CASE #PL2021-42

WALSER TOYOTA BLOOMINGTON, MN

Reviewed for Code Compliance
Date: 11/04/2022
By: K. Bayer
Plan # PRBD202210606

2022 NEW BUILDING FOR:
WALSER TOYOTA
4401 AMERICAN BLVD
BLOOMINGTON, MINNESOTA

1 ROOF PLAN
1/2" = 1'-0" NORTH

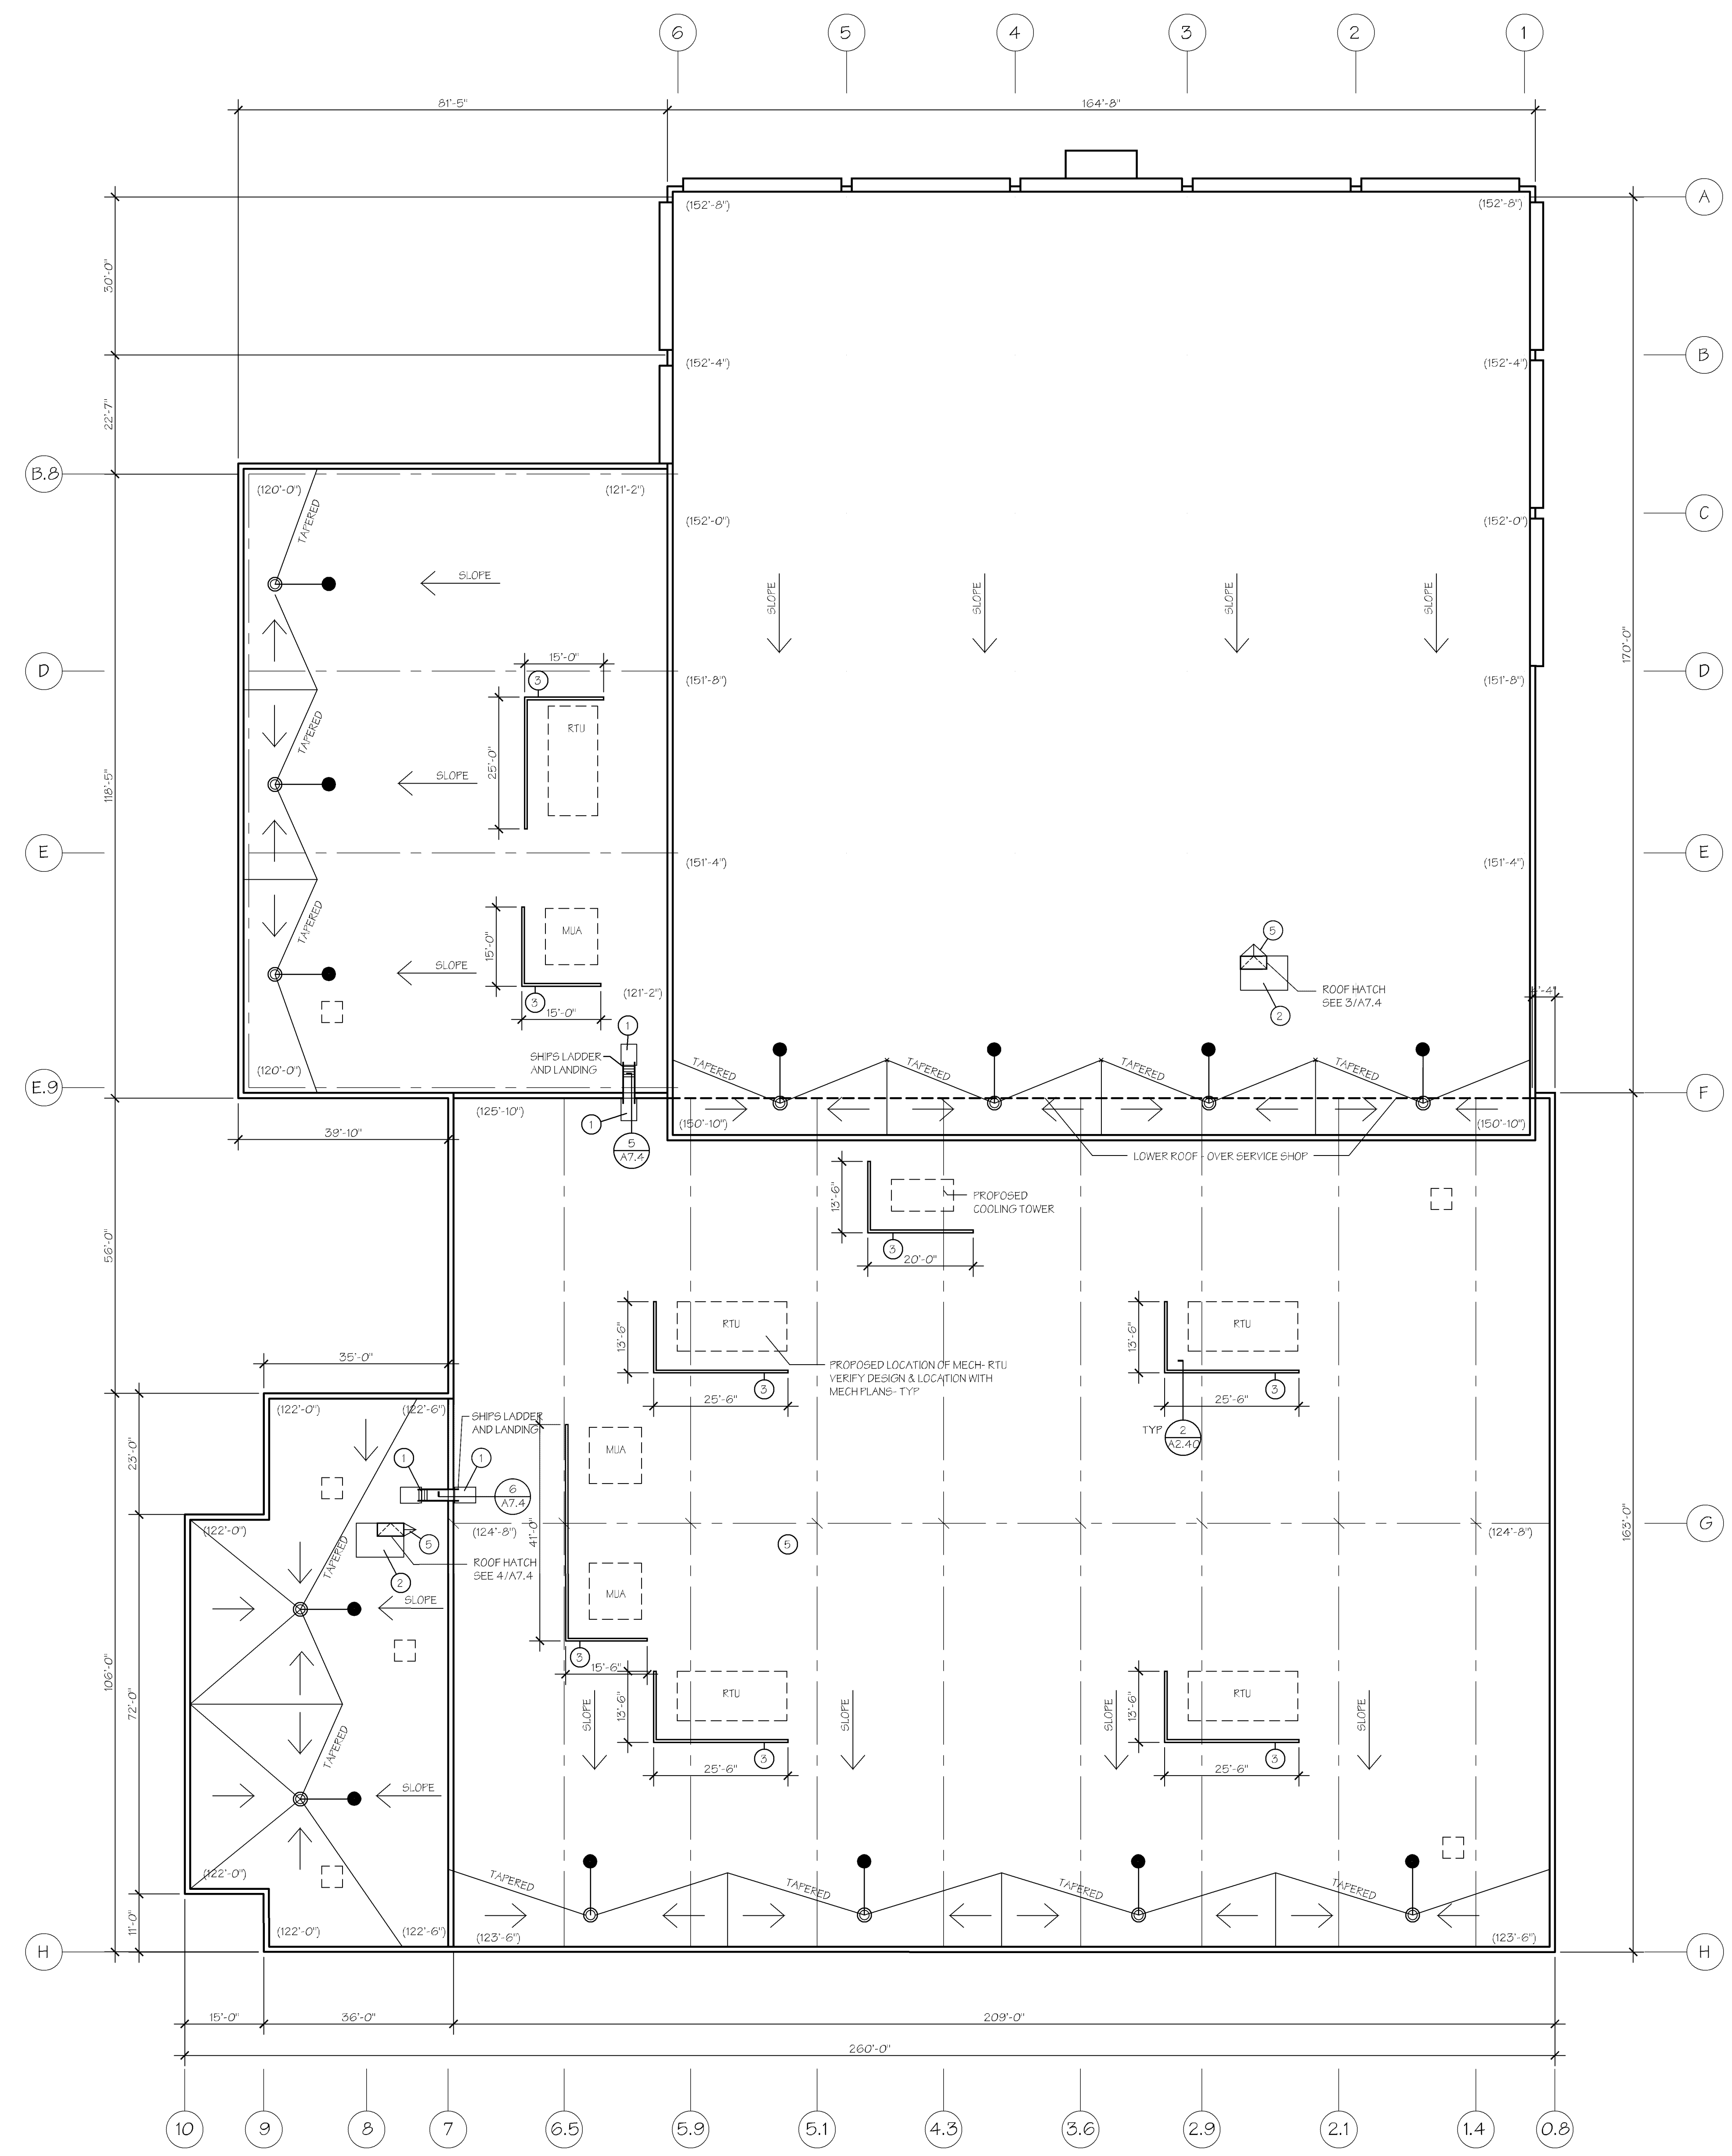
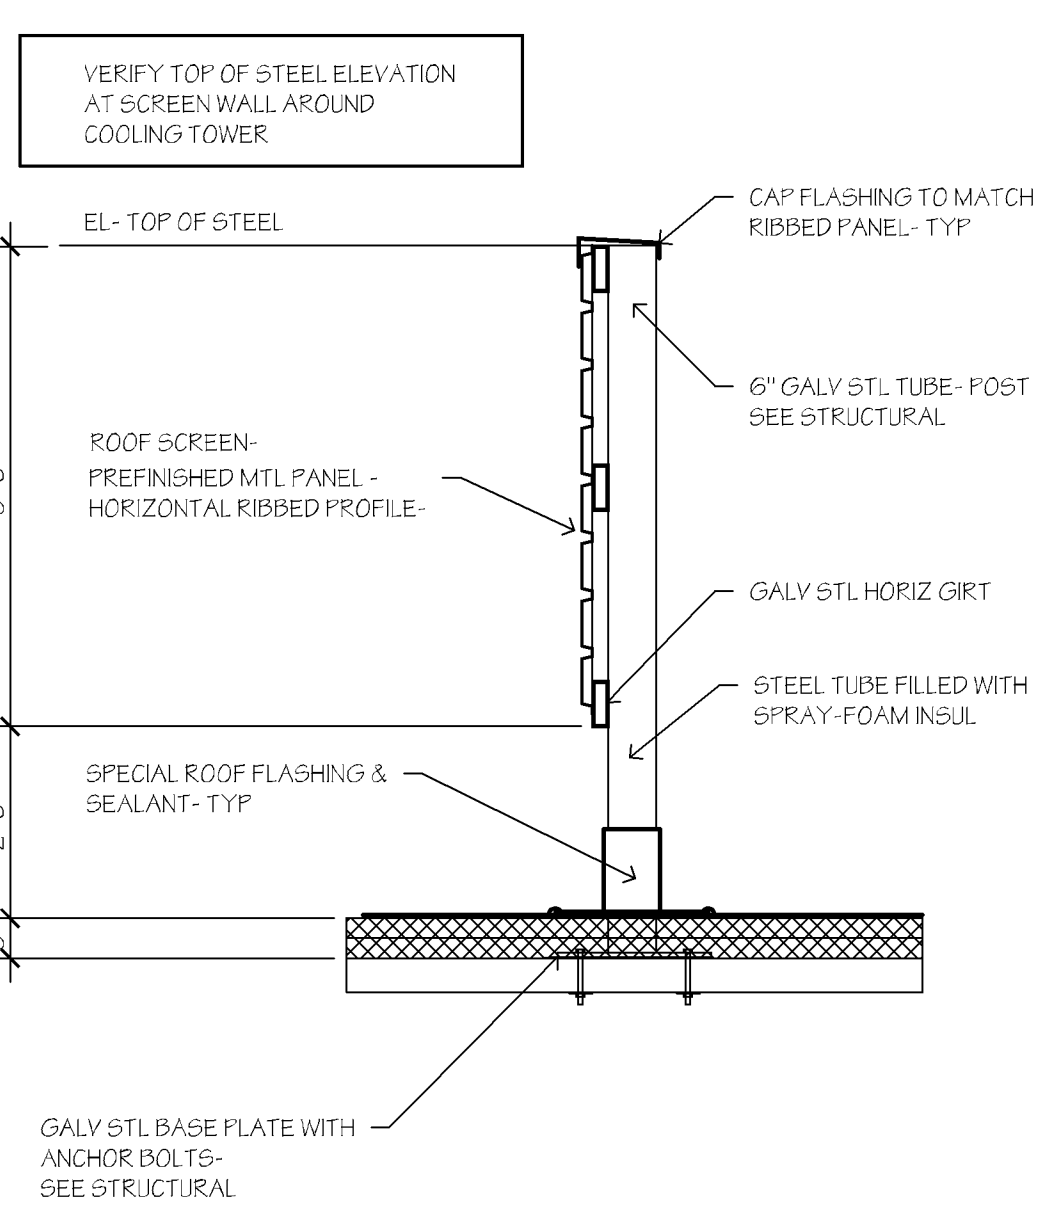
Screening of all mechanical equipment shall meet City of Bloomington Zoning requirements.

Refer to Section 1502.2 of 2020 IBC for secondary roof drain system requirements. Overflow drains shall not discharge onto public sidewalks.
